KING'S MAPLE STREET SECOND ADDITION
WICHITA, SEDGWICK COUNTY, KANSAS

RE: SUB 2000-43 -- Final Plat of King's Maple Street Second Addition

CASE NUMBER: SUB 2000-43 -- KING'S MAPLE STREET SECOND ADDITION

SUB 2000-43 -- Revised One-Step Final Plat of KING'S MAPLE STREET SECOND ADDITION
March 21, 2002 - Page 3

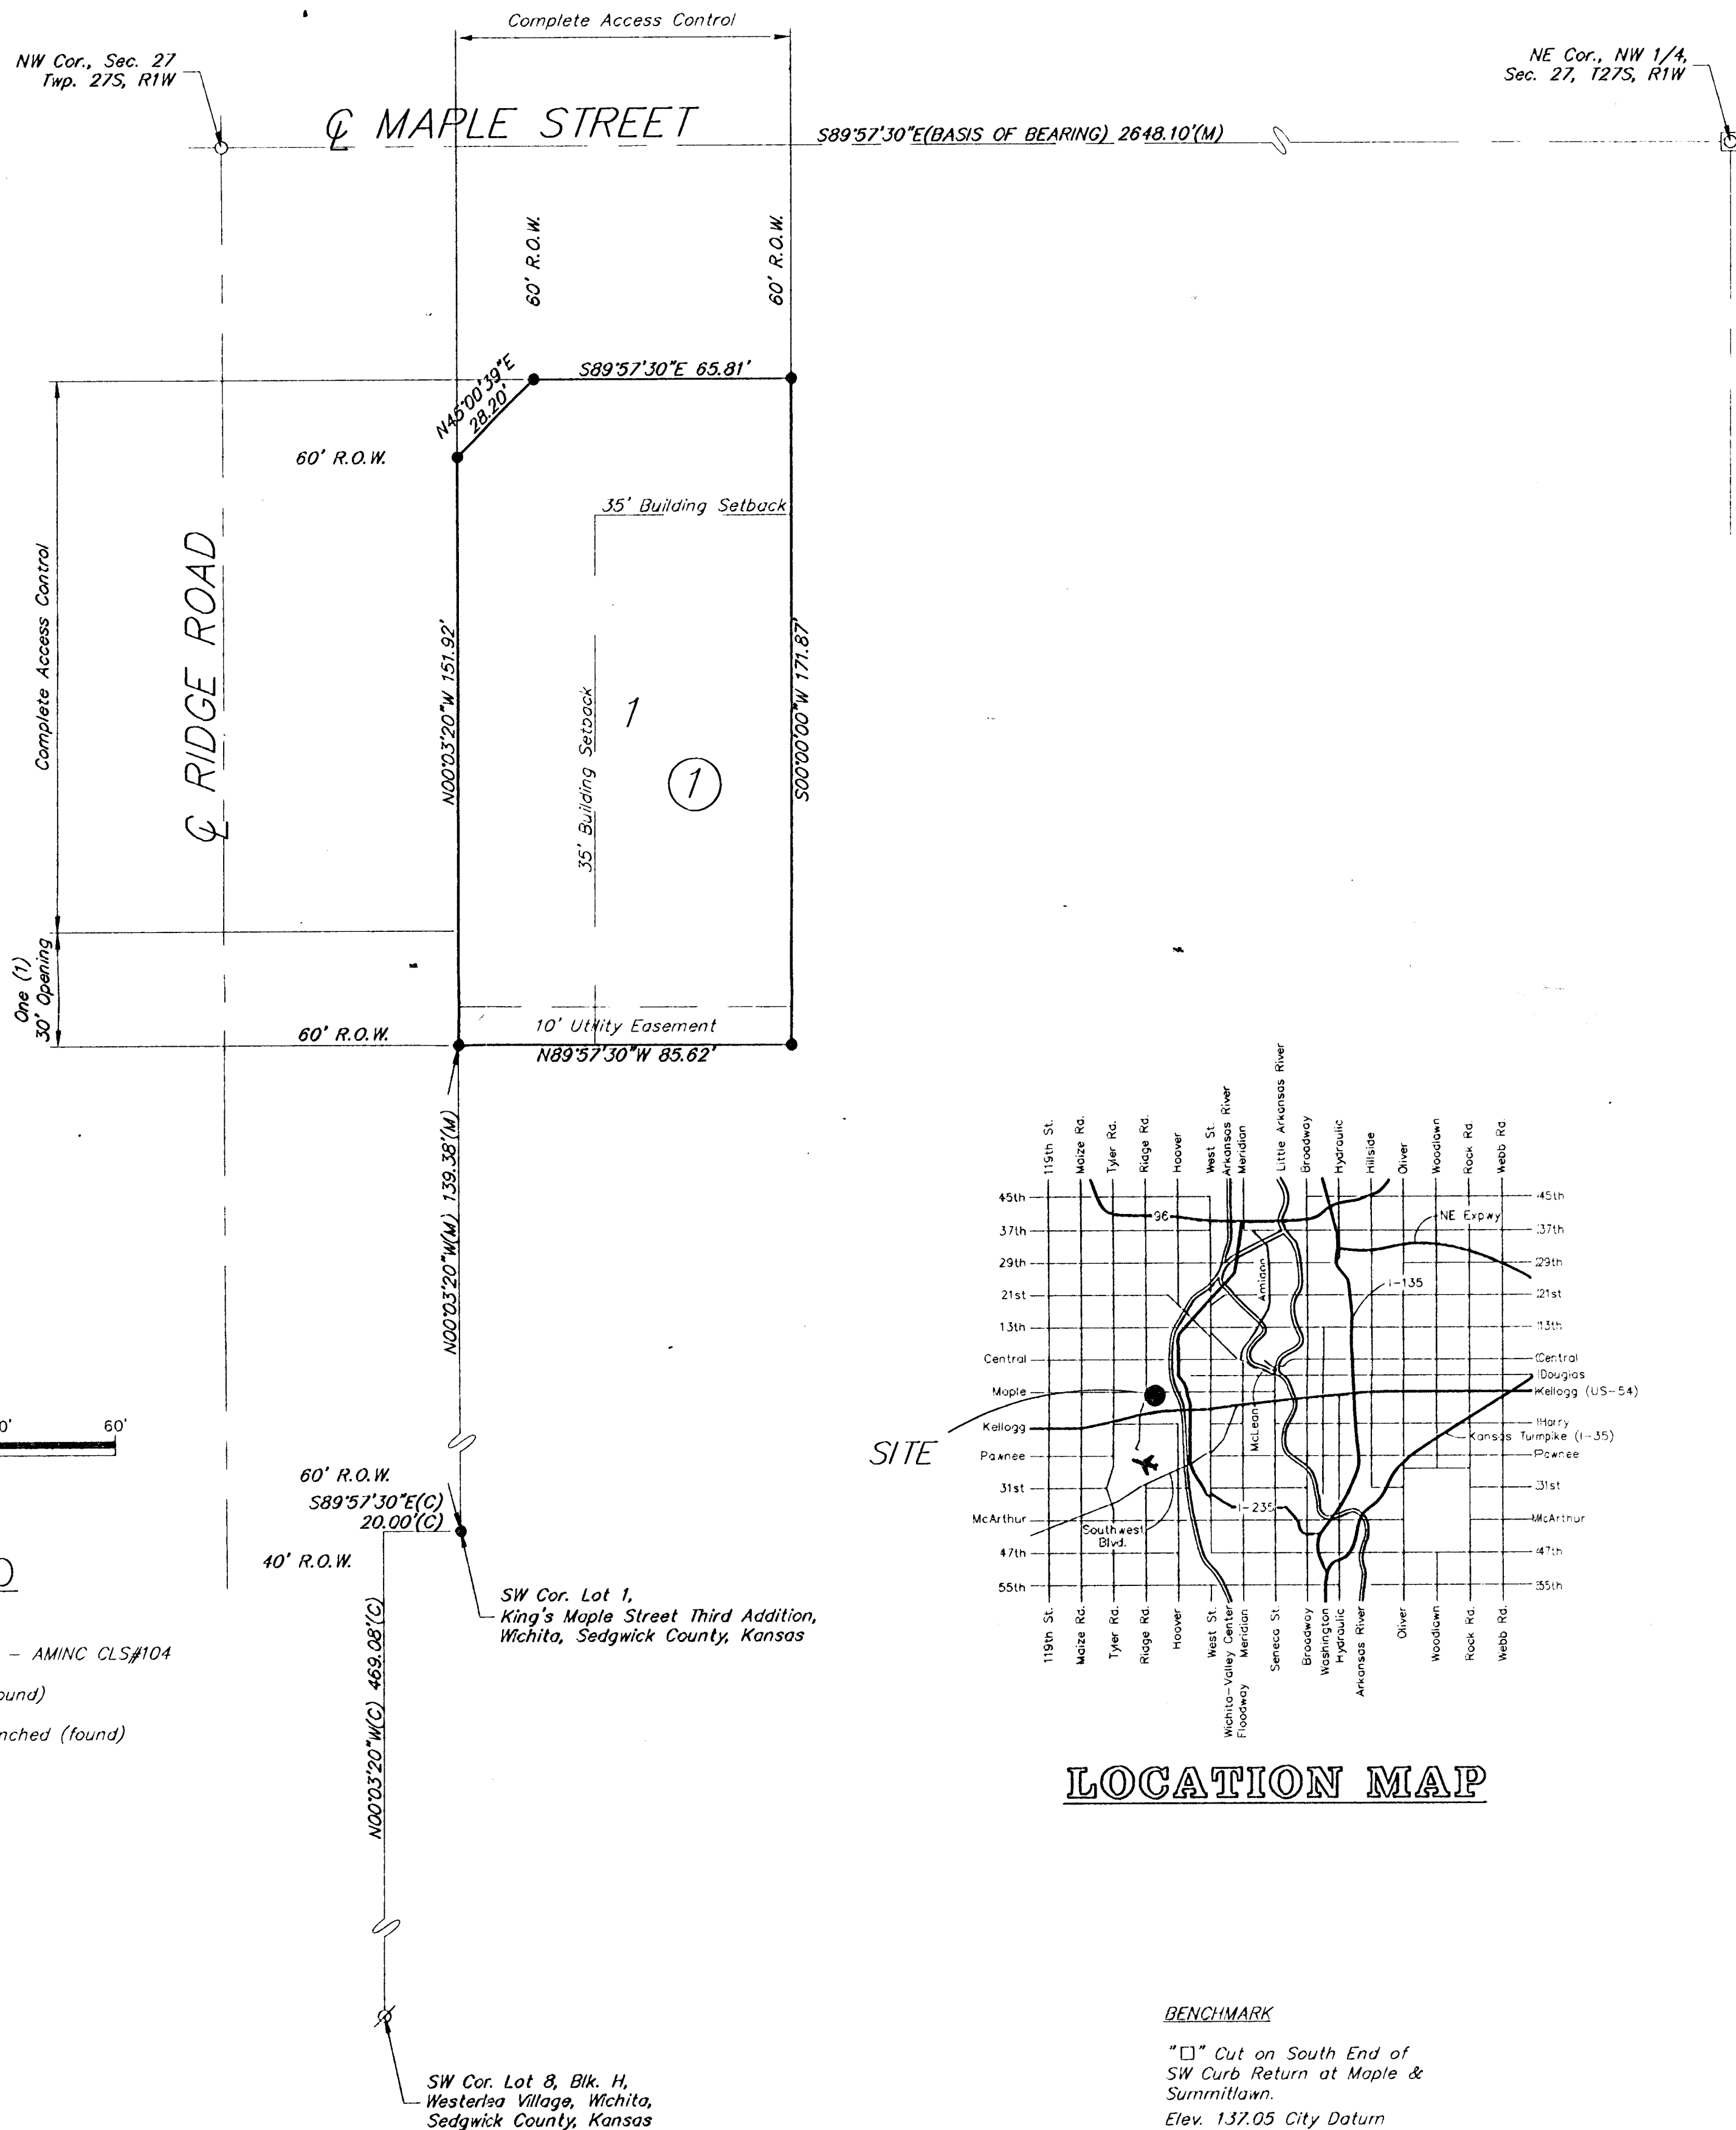
- A. Municipal services are available to serve the site. City Engineering needs to comment on the need for any guarantees or easements. No guarantees are required.

- C. City Engineering needs to comment on the status of the applicant's drainage plan. An off-site drainage agreement is needed.
- D. Dedication of access control except for one opening along the frontage of Ridge Road was required by Protective Overlay #63 associated with Z-3350; however this plat and the abutting plat to the south (King's Maple St. 3rd) indicates a total of two openings. MAPD recommends a joint opening be denoted along the south line of the plat and 150 feet of complete access control dedicated from the intersection. In accordance with the Subdivision regulations, any access openings located within 250 feet of the intersection of Maple and Ridge Road are limited to right-turns only, and shall be referenced on the face of the plat; or a guarantee provided for the future construction of a raised medial. The Subdivision Committee has approved a joint opening located along the south line of the plat.

- E. The joint access opening shall be established by separate instrument. Initial construction responsibilities and future maintenance of the driveway within the easement should also be addressed by the text of the instrument.

- F. The applicant shall guarantee the closure of any driveway openings located in areas of complete access control or that exceed the number of allowed openings.

- G. **Traffic Engineering** needs to comment on the need for the dedication of any additional right-of-way. The plat indicates a "corner clip" with a 60-ft half-street right-of-way in lieu of the standard 75-ft major street intersection. The street right-of-way is approved.

- M. On the final plat, the MAPC signature block needs to reference "J.D. Michaelis, Chair".
- N. The legal description needs to be corrected.
- O. The platting binder indicates that a drainage plan has been developed for the plat and that all drainage easements, rights-of-way, or reserves shall remain at established grades or as modified with the approval of the applicable City or County Engineer, and unobstructed to allow for the conveyance of stormwater.

A 5-ft sidewalk easement within
A 10-ft utility easement is required
(per Traffic Eng.)

- W. The representatives from the utility companies should be prepared to comment on the need for any additional utility easements to be platted on this property. *Southwestern Bell has advised that overhead facilities are located within existing easements. Said easements need to be maintained, or the applicant shall pay costs to relocate the cables.*

The Subdivision Committee has approved one opening located along the south line of the plat. A Cross-Lot Access Agreement is needed with the property to the south.
